ADDENDUM # 03

Project: Mt Diablo Unified School District
Mt Diablo Elementary School
Modernization of Three Elementary School Campuses, INC 2
19six #: 23120
DSA #: 01-121407
Bid #: 1945
Date: November 19, 2024

SHEET NO.
2-C1.1

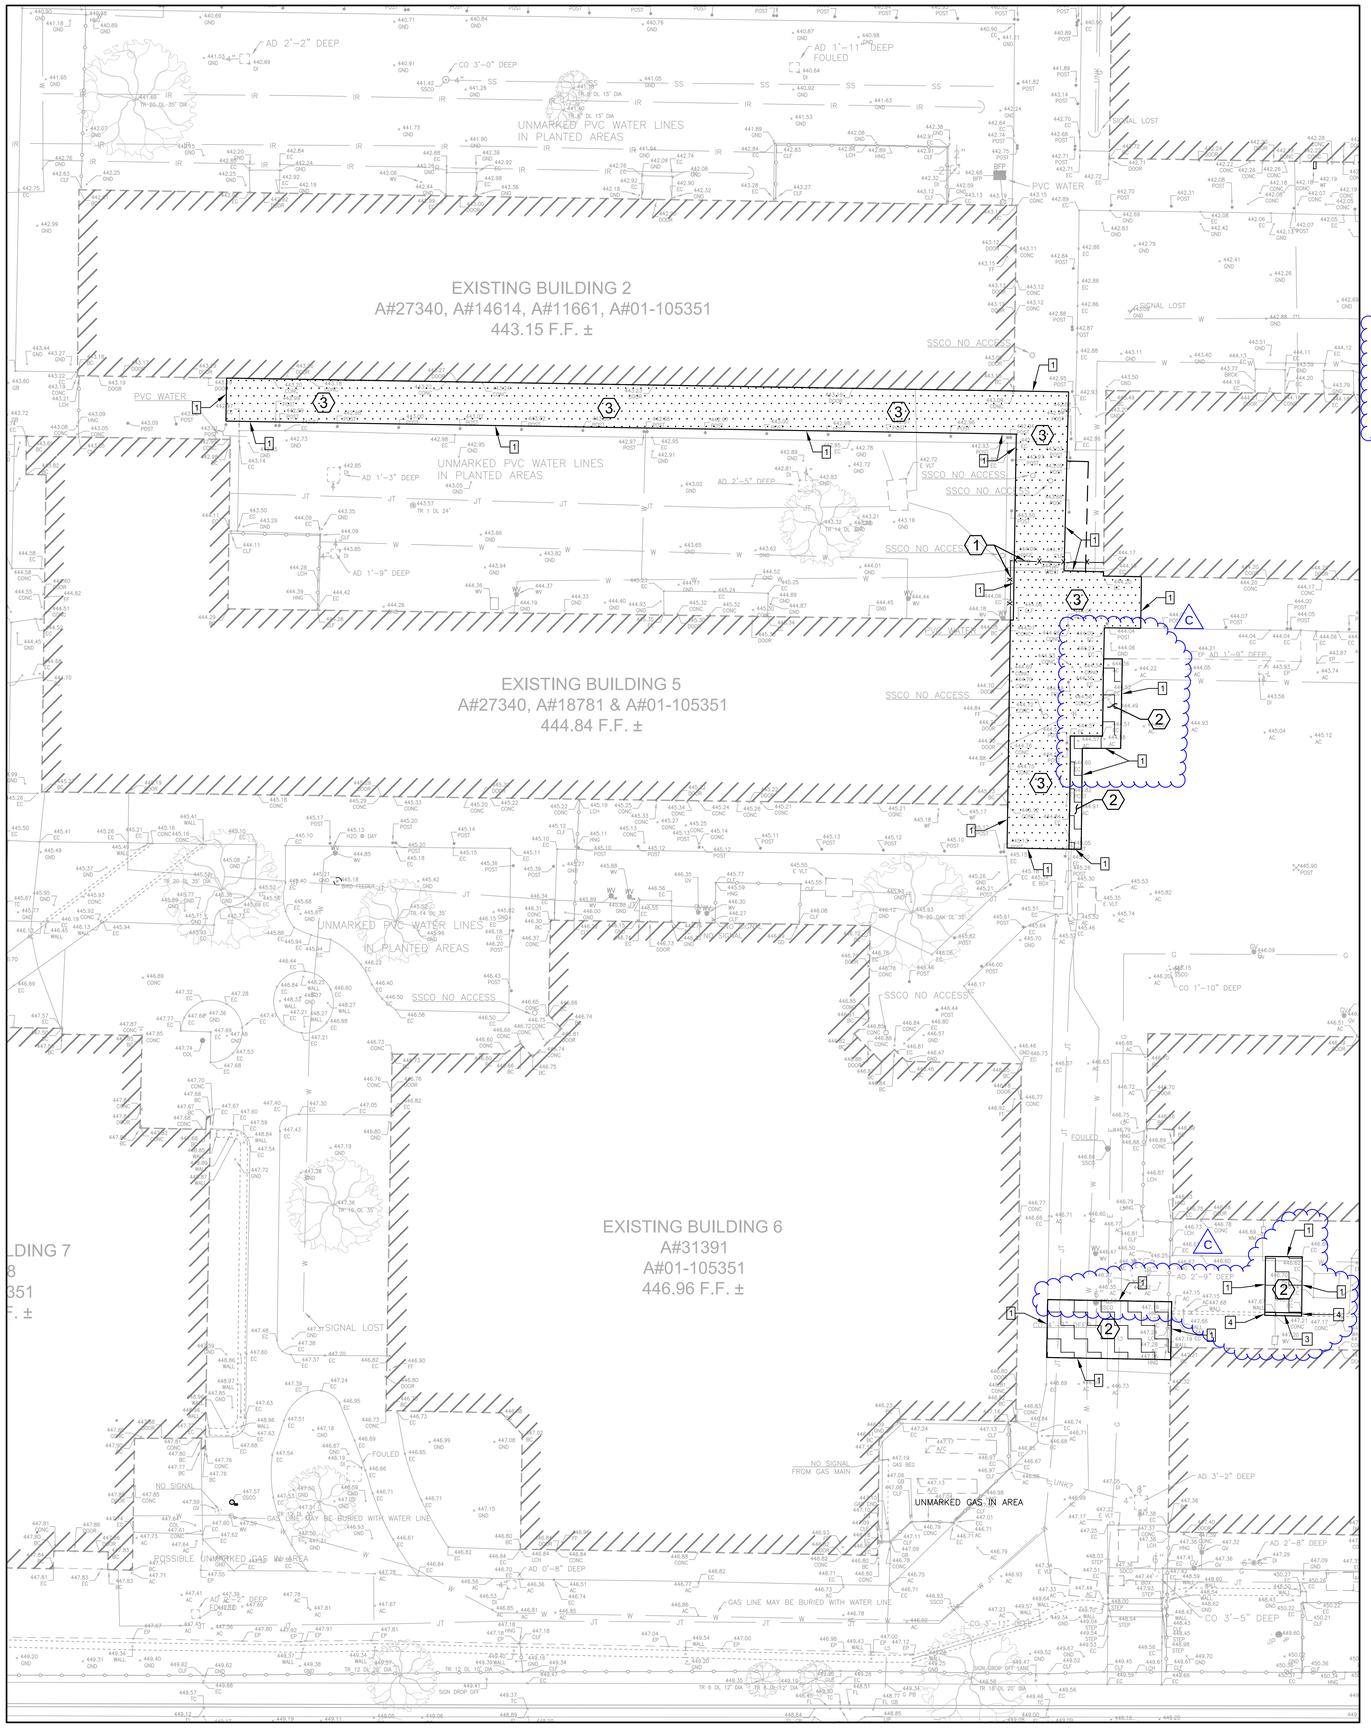
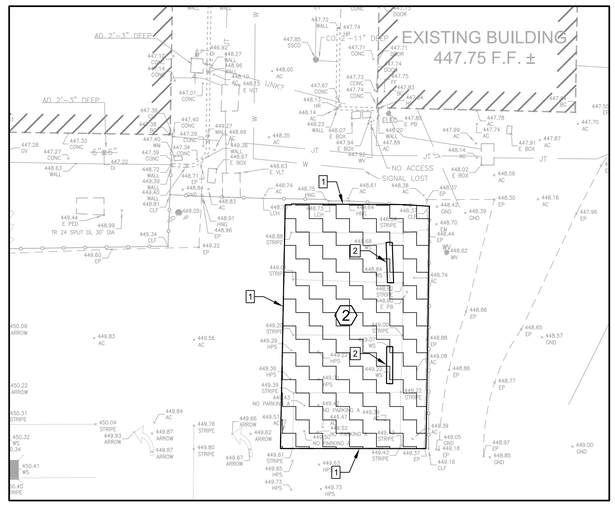
ITEM 1. **2-C1.1 DEMOLITION PLAN**
- Change in the demolition plan to reduce demolition required, see revised keynote 3 & 4

KEYNOTE	DESCRIPTION	
1	SAWCUT ASPHALT OR REMOVE CONCRETE TO NEAREST CONTROL JOINT	
2	REMOVE & REINSTALL PARKING BUMPER	C
3	REMOVE CURB	
4	EXTENT OF CURB REMOVAL

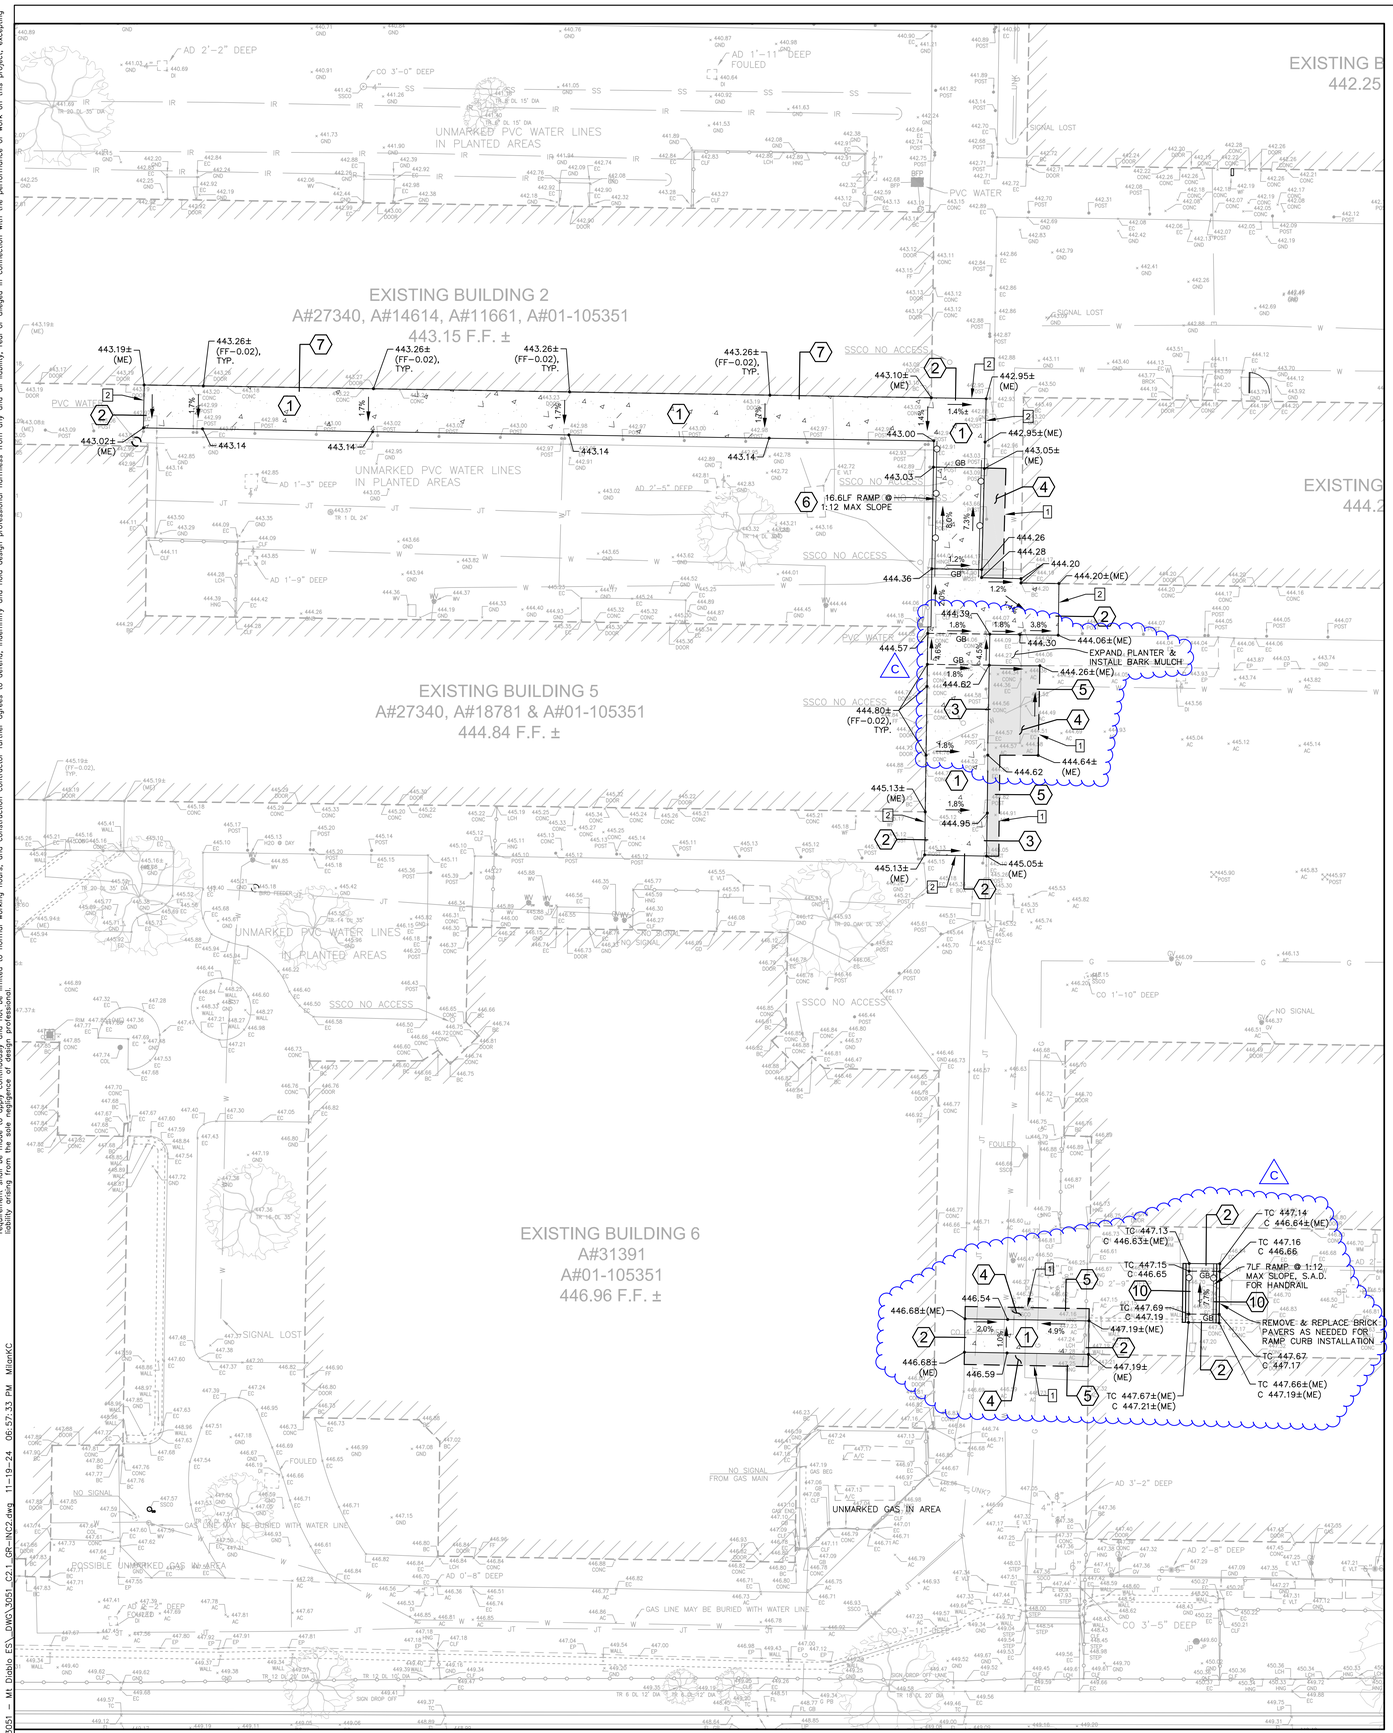
ITEM 2. **2-C2.1 GRADING & DRAINAGE PLAN**
- See revised keynote 10
- Added new ramp between building 9 & 10

16.6LF RAMP @ 1:12 MAX SLOPE
EXPAND, PLANTER & INSTALL BARK MULCH
REMOVE & REPLACE BRICK PAVERS AS NEEDED FOR RAMP CURB INSTALLATION
7LF. RAMP @ 1:12 MAX SLOPE, S.A.D. FOR HANDRAIL

SHEET NO.
2-C3.1

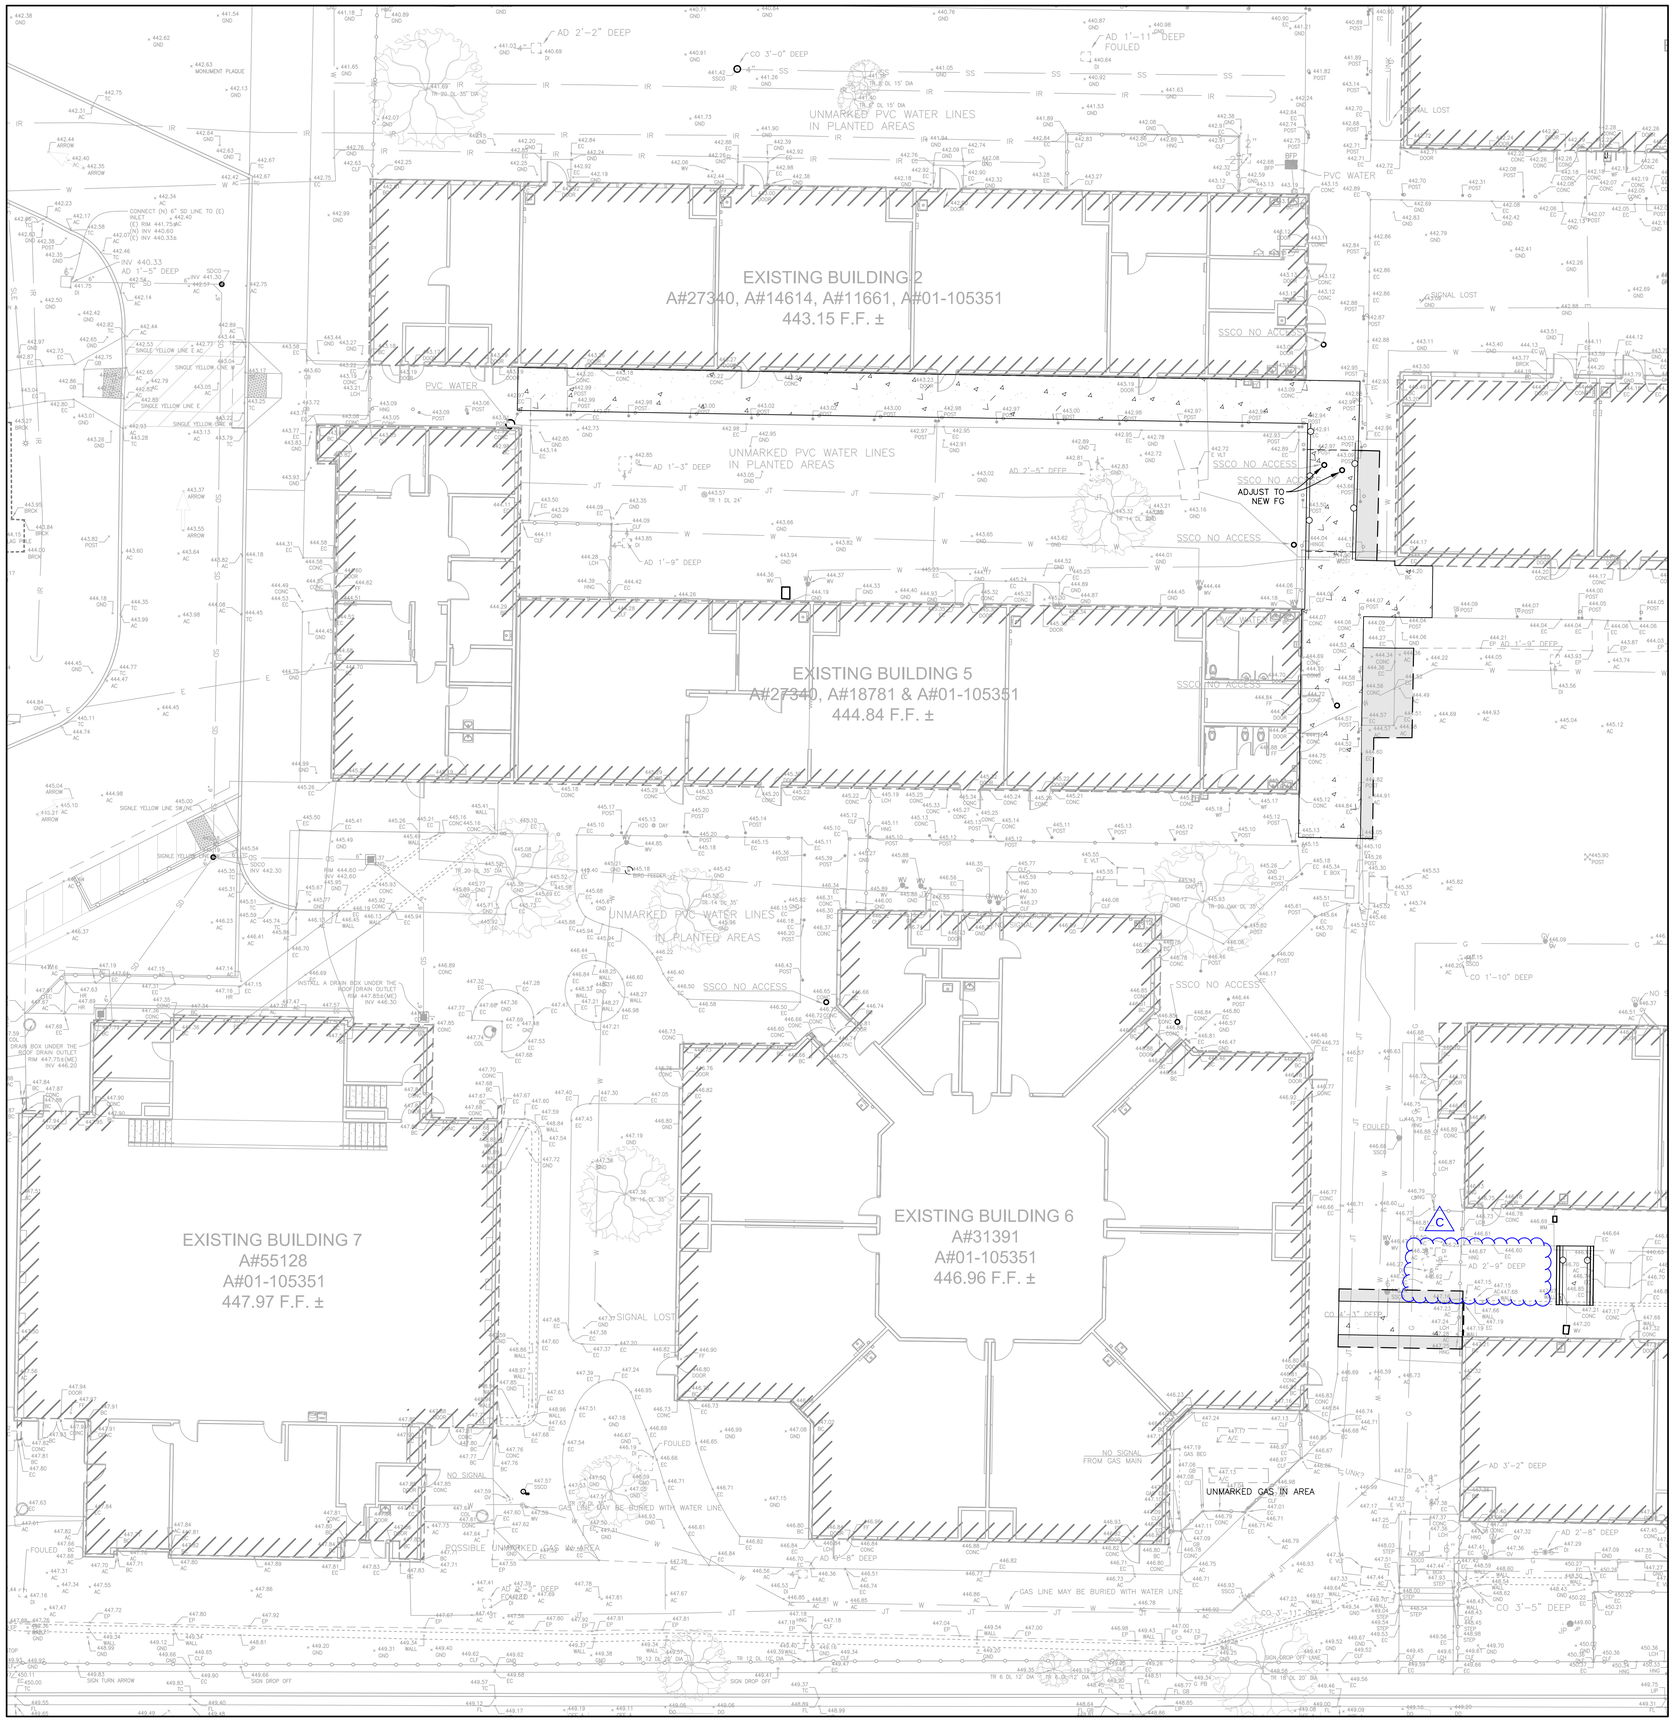
ITEM 3. **2-C3.1 UNDERGROUND UTILITIES PLAN**
- Reduced the amount of demolition required

SHEET NO.
2-C4.1

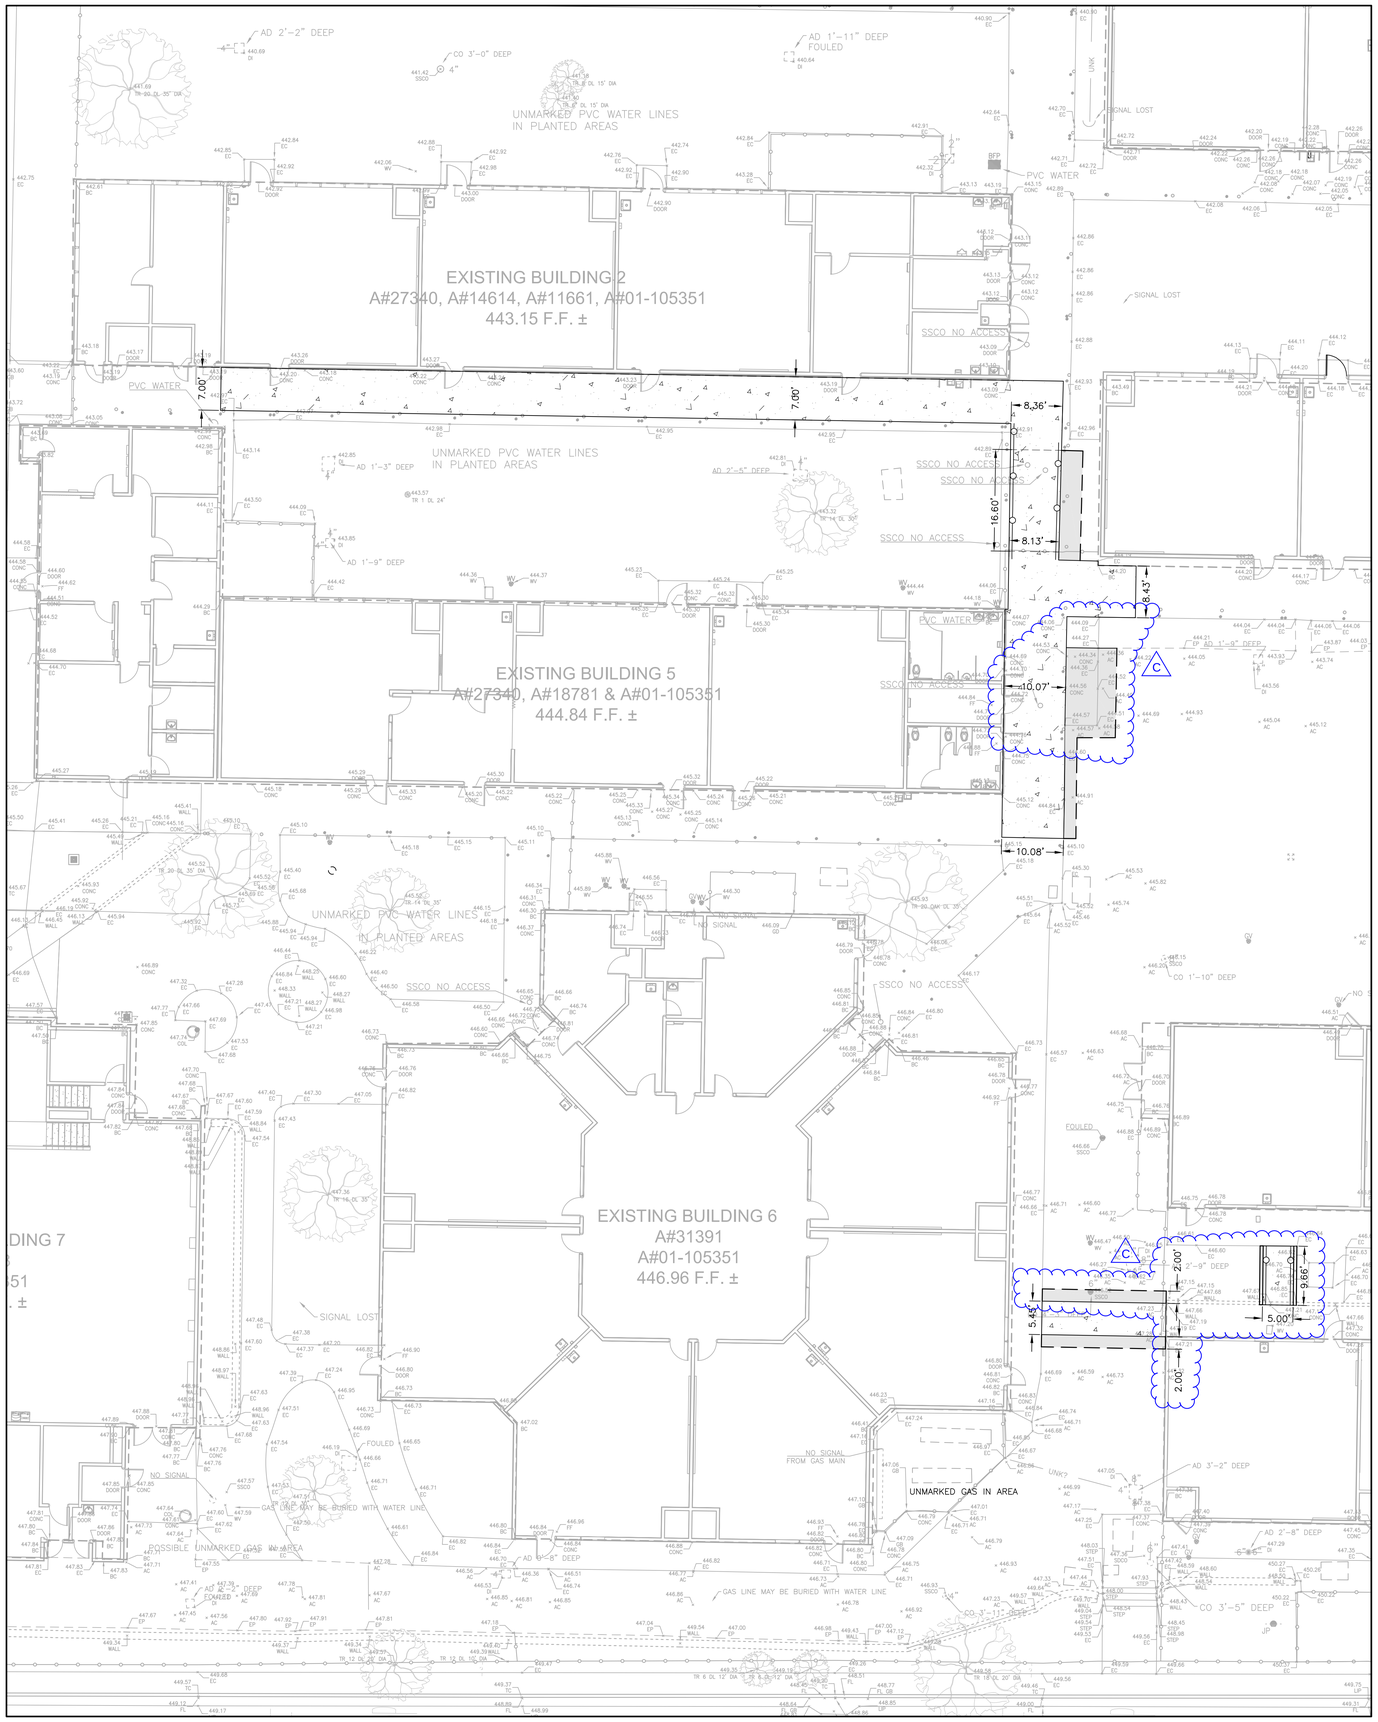
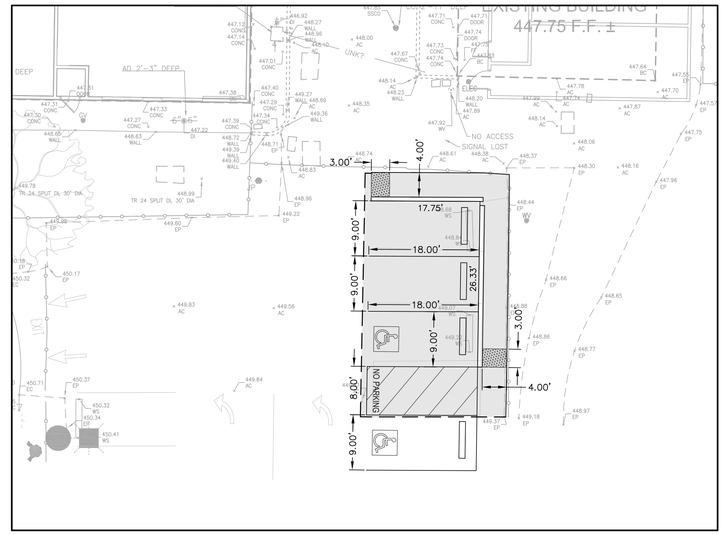
ITEM 4. **2-C4.1 HORIZONTAL CONTROL PLAN**
- Change in design to add new ramp
- Modified extent of concrete and asphalt

9 EDGE OF RAMP - TYPE II

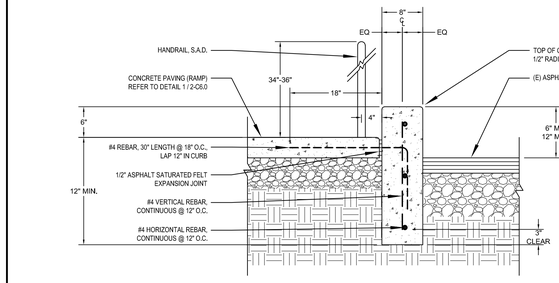
ITEM 5. **2-C6.0 DETAILS**
- Addition of detail 9

NOTES:
1. CONCRETE CURB TO RECEIVE SACK FINISH.
2. INSTALL VERTICAL SCORE JOINTS 10'-0" O.C. MAX. WITH 1/2" RADIUS EDGES.
3. INSTALL VERTICAL ASPHALTIC SATURATED EXPANSION JOINTS EVENLY SPACED @ 20'-0" O.C. MAX. PROVIDE 1" CHAMFER EDGES AT EXPANSION JOINTS.
